RE: OZS-2024- 0062

*Formal Comments Response to the
Development Proposal Located at 3407
Countryside Drive*

Our Concerns

Tree Inventory and Preservation Plan

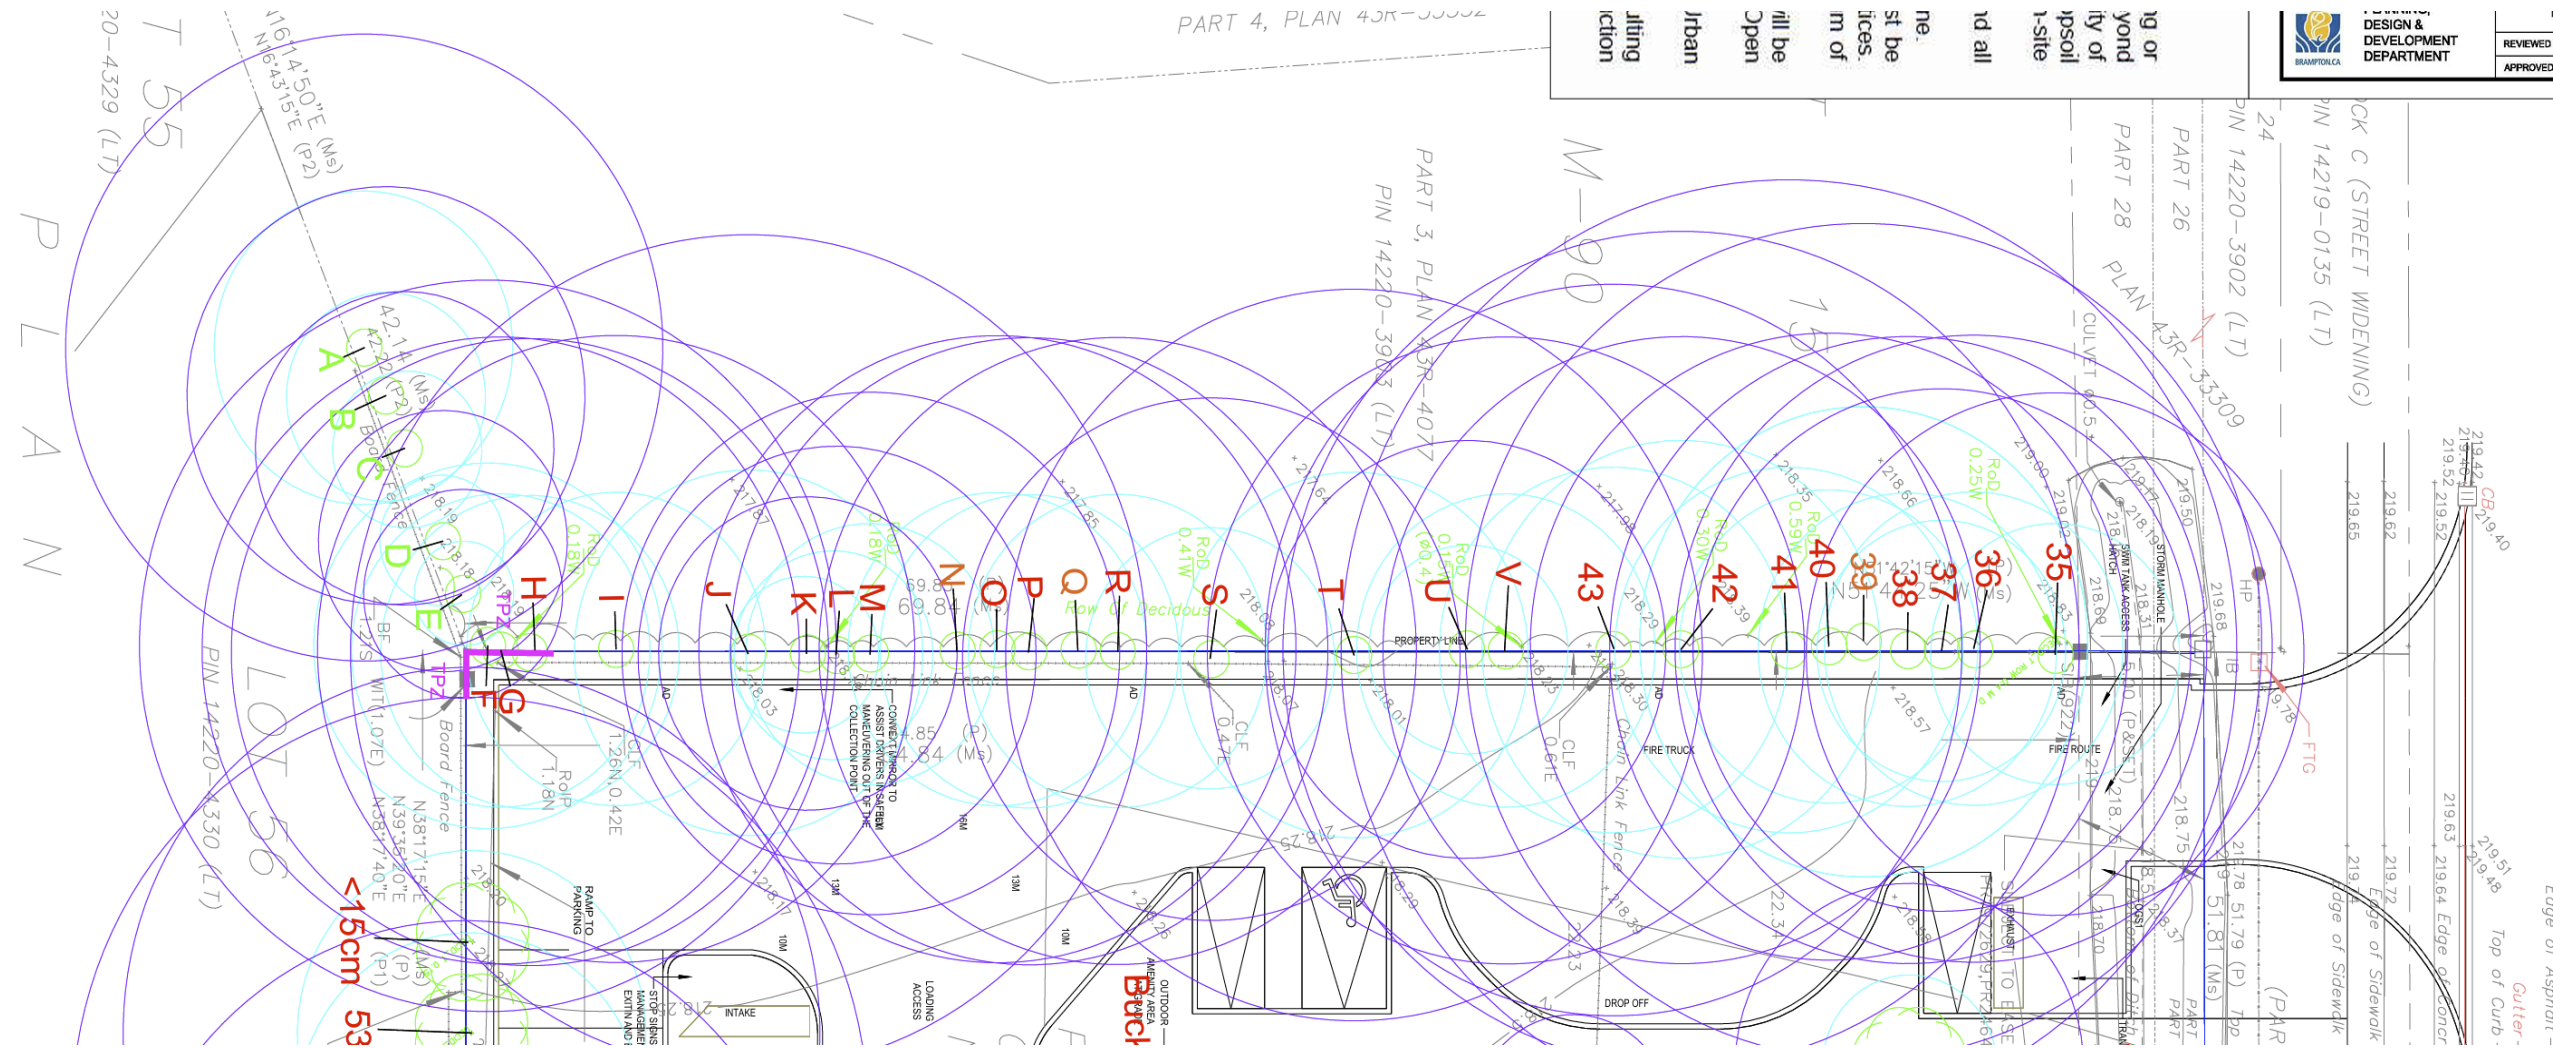
- ☐ The trees identified on the Mauro Group SRPR and the Tree Inventory and Preservation Plan are "Boundary Trees" and "Border Trees".
- ☐ Section 10(2) Ontario Forestry Act states "every tree whose trunk is growing on the boundary between adjoining lands is the common property of the owners of the adjoining lands".
- ☐ City of Brampton Tree Preservation By-law 317-2012 states under PART VI Application 20.e that "The written consent of the adjacent property owner if the Tree to be injured is a boundary tree."

A total of 23/39 Boundary Trees are proposed to be removed and will need consent of both owners to proceed.

Tree label (GREEN) preservation recommended: A, B, C, D & E are located within our client's property are classified as Border Trees.

Tree label (RED) removal required for development: F, G, H, I, J, K, L, M, O, P, R, S, T, U, V, 35, 36, 37, 41, 42 & 43 are Boundary Trees.

Tree Label (ORANGE) removal recommended due to condition: N, Q, & 39 are Boundary Trees.

Proposed 1.003m Buffer

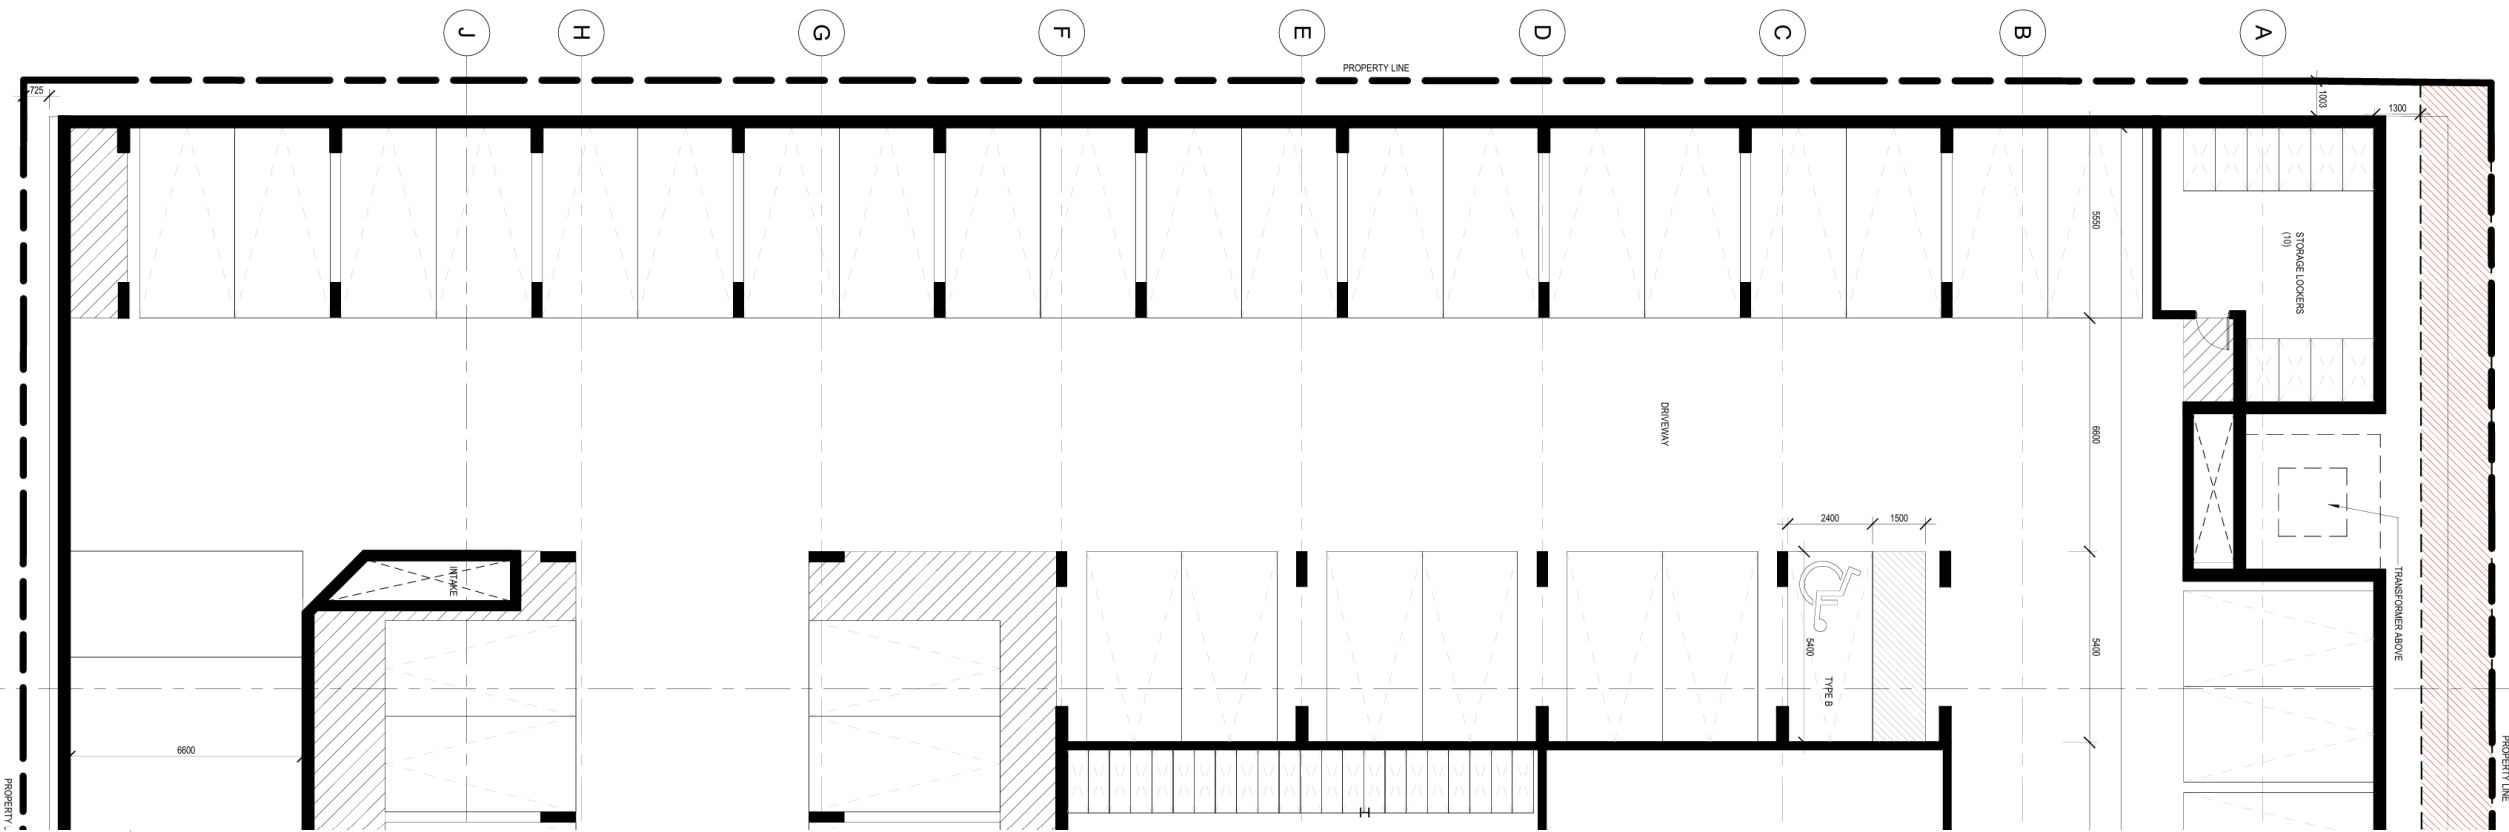
Our Opinion: Proposal in its current form is not possible without the consent of the adjacent owner.

- ☐ *The proposal is seeking a 1.003m landscape strip where the Boundary Trees exist.*
- ☐ *Boundary Trees identified on the TIPP will interfere with the proposals at-grade and underground parking structure P2 and P3, the proposed SWM Tanks and Storage areas below-grade.*
- ☐ *Shoring and excavation is not possible without the removal of the Boundary Trees for the footings and foundation walls for the underground parking structure.*
- ☐ **Notwithstanding Staff's opinion that a 3m buffer is needed abutting our client's property line (initial comment response matrix); the underground structure will shift or shrink by 2m and result in a redesign for at-grade design and within P2 and P3.**

Tertiary Plan: Original Submission (R0)

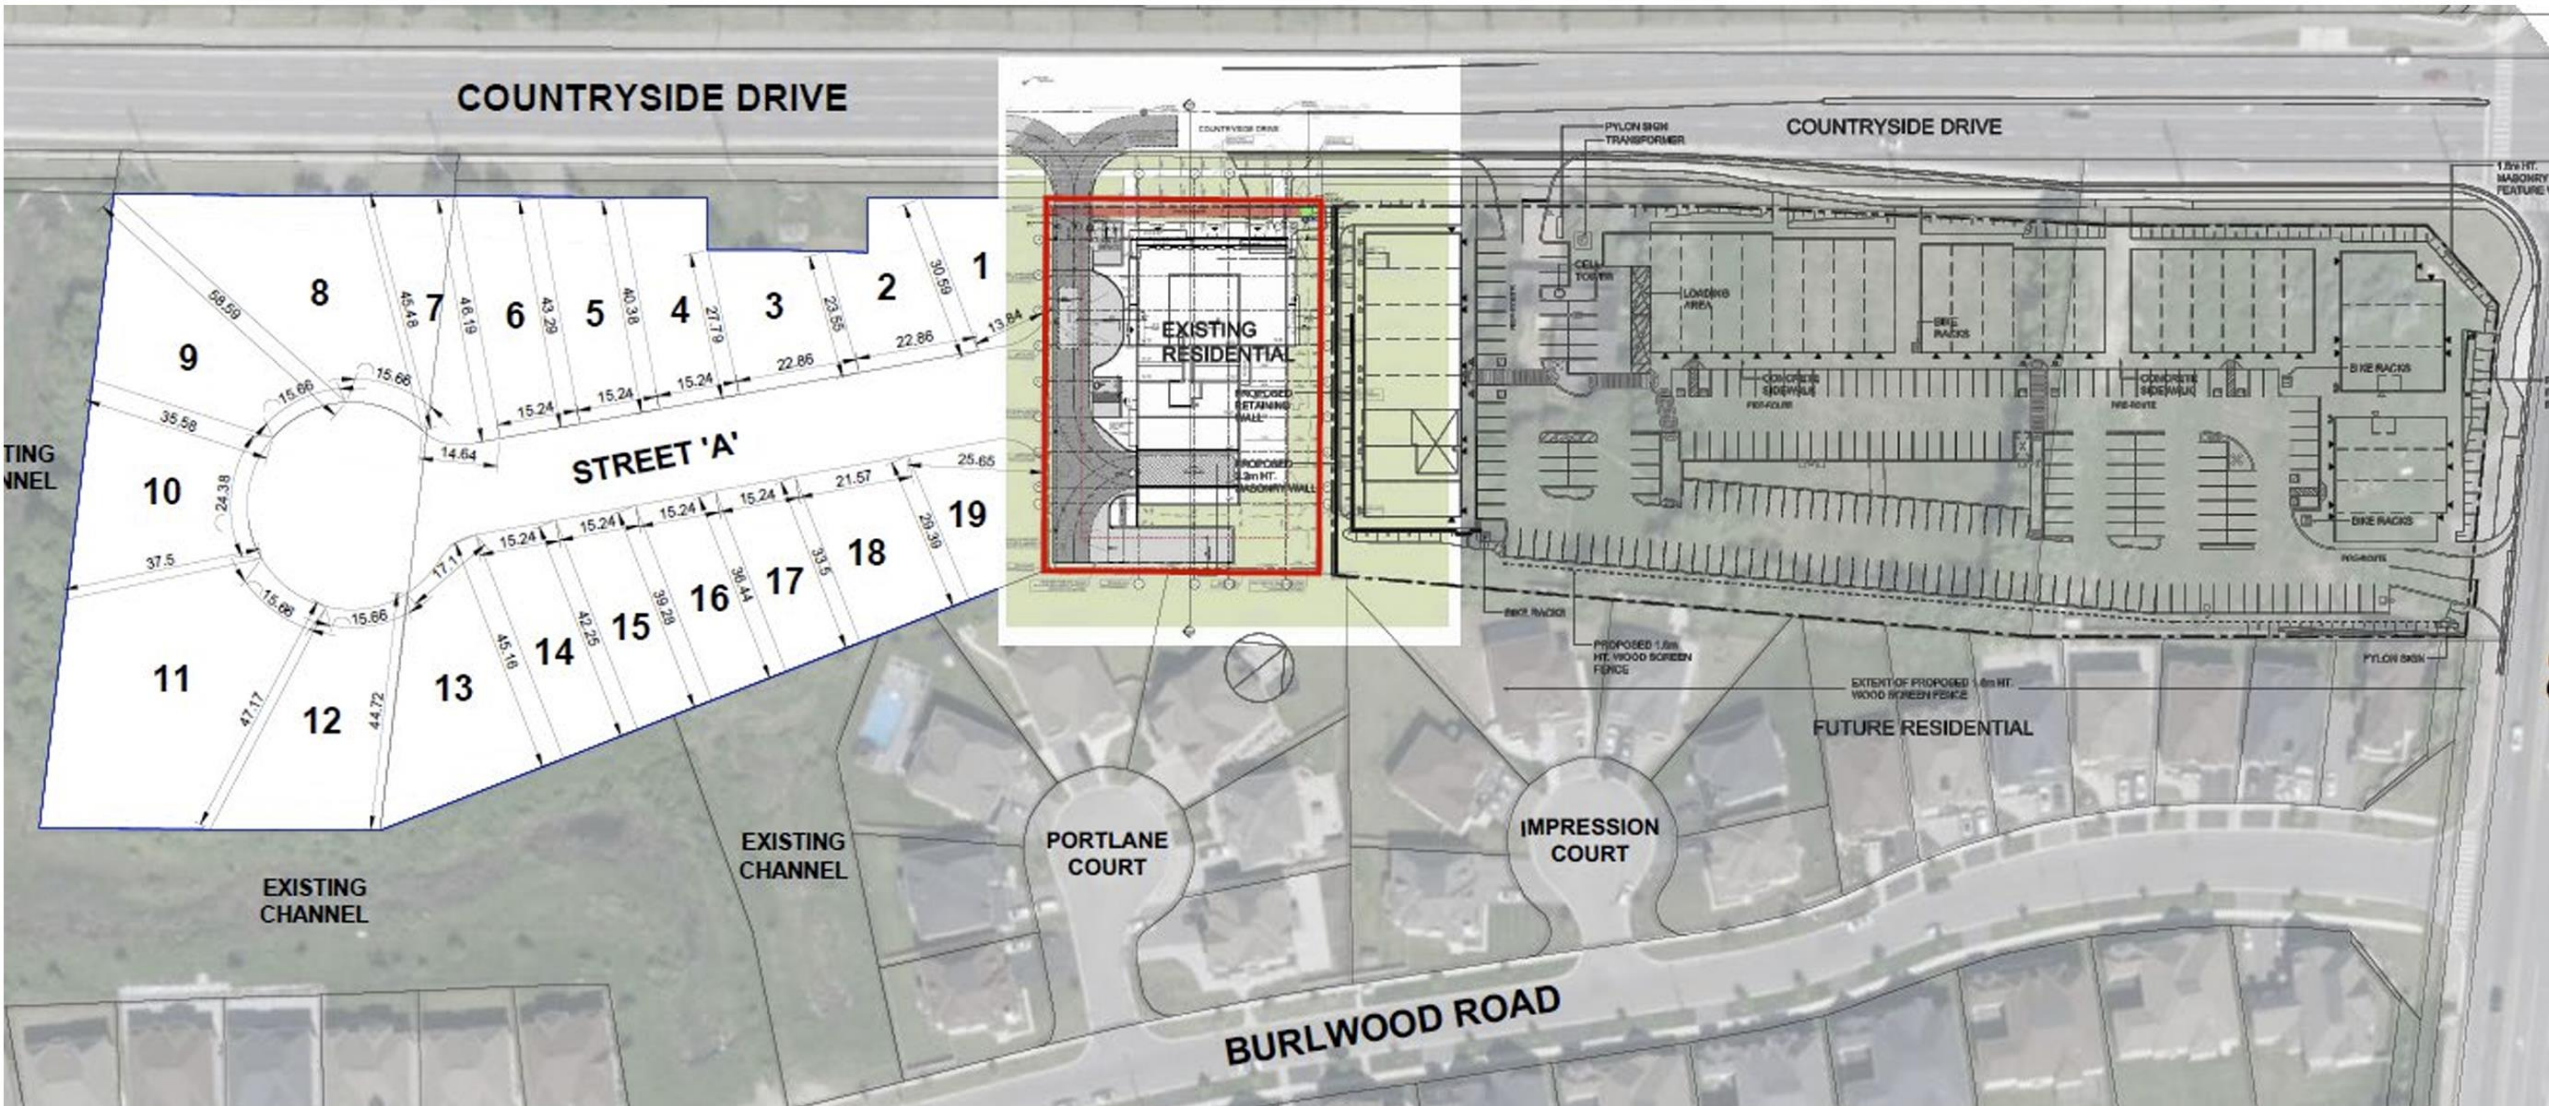
- ☐ *The R0 Tertiary Plan cannot functionally work given the site context and constraints.*
- ☐ *Issue with the proposed "mutual access" through the proposed driveway will be challenging and create maneuvering challenges in the adjacent lots, loading/waste collection vehicles, and flow from the underground ramp.*
- ☐ *The submitted studies do not provide any details on the design and potential challenges of the R0 Tertiary Plan.*

The Tertiary Plan provided with the pre-consultation application submission is more suitable.
